GNF CRDA Application Methodology NEDO-33885-A,
Revision 1, March 2020

GNF CRDA Application Methodology

SUBJECT: FINAL SAFETY EVALUATION FOR GLOBAL NUCLEAR FUEL – AMERICAS, LLC (GNF) LICENSING TOPICAL REPORT NEDE-33885P, REVISION 0, “GNF CONTROL ROD DROP ACCIDENT APPLICATION METHODOLOGY” (EPID L-2018-TOP-0006)

Figure 1: Time Step Sizes for Table 5-3 Cases

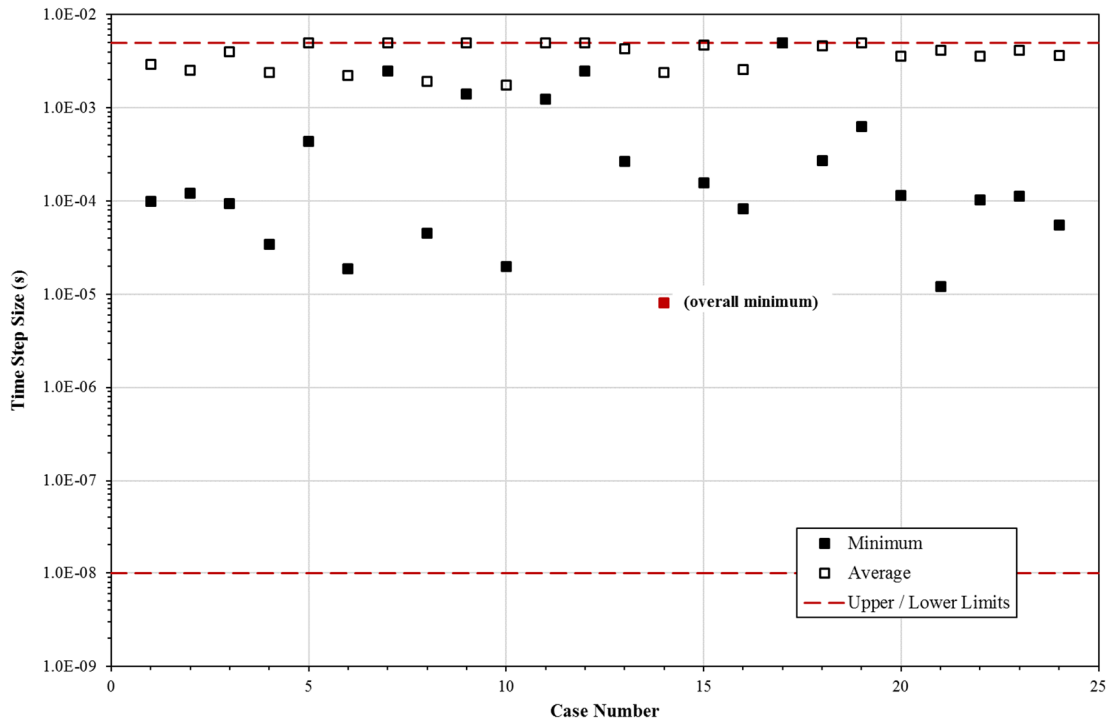
Figure 1 presents the minimum and average time step size for each case compared to the minimum and maximum allowable time step size. The minimum time step size actually used was 8.07E-06 seconds which is roughly two orders of magnitude from the 1.0E-08 second minimum allowable time step size. The average time step size is approximately 3.76E-03 seconds. This example demonstrates that the specified lower limit on allowable time step size is sufficiently low that its value will not affect the results.

Figure 2: Time Step Sizes for Table 5-3 Limiting Case

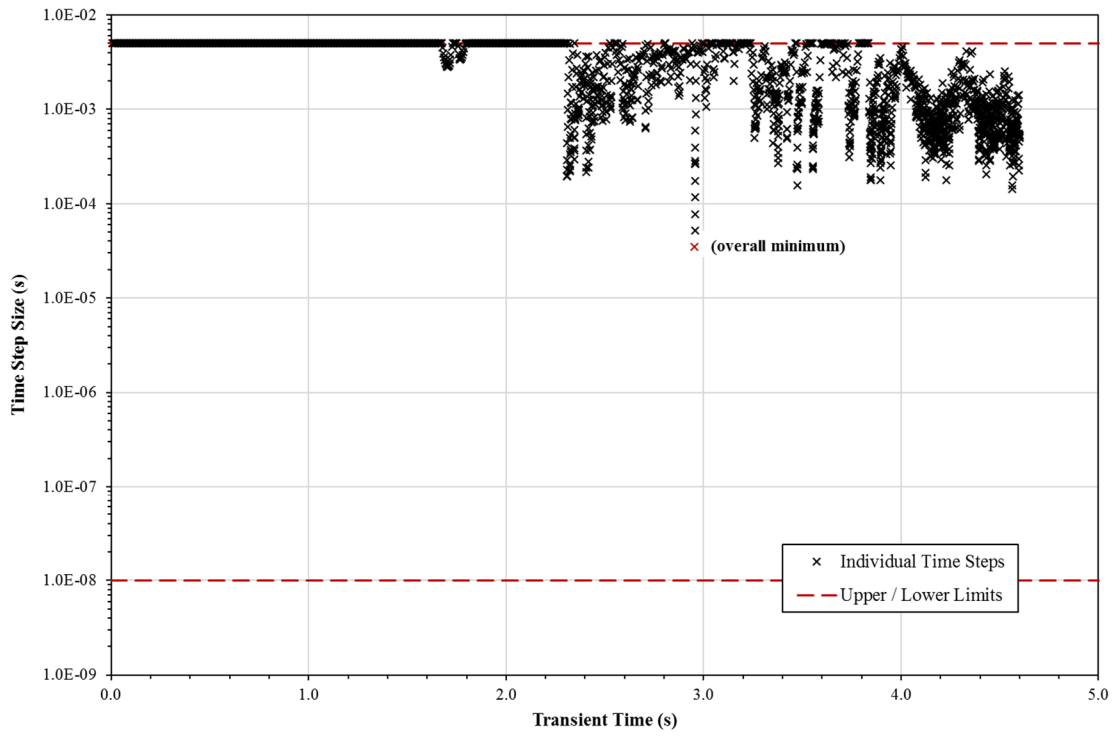
Figure 2 presents the individual time step sizes for the case with the highest overall ratio to either the pellet-cladding mechanical interaction or the high temperature cladding failure acceptance criteria in Table 5-3. [[
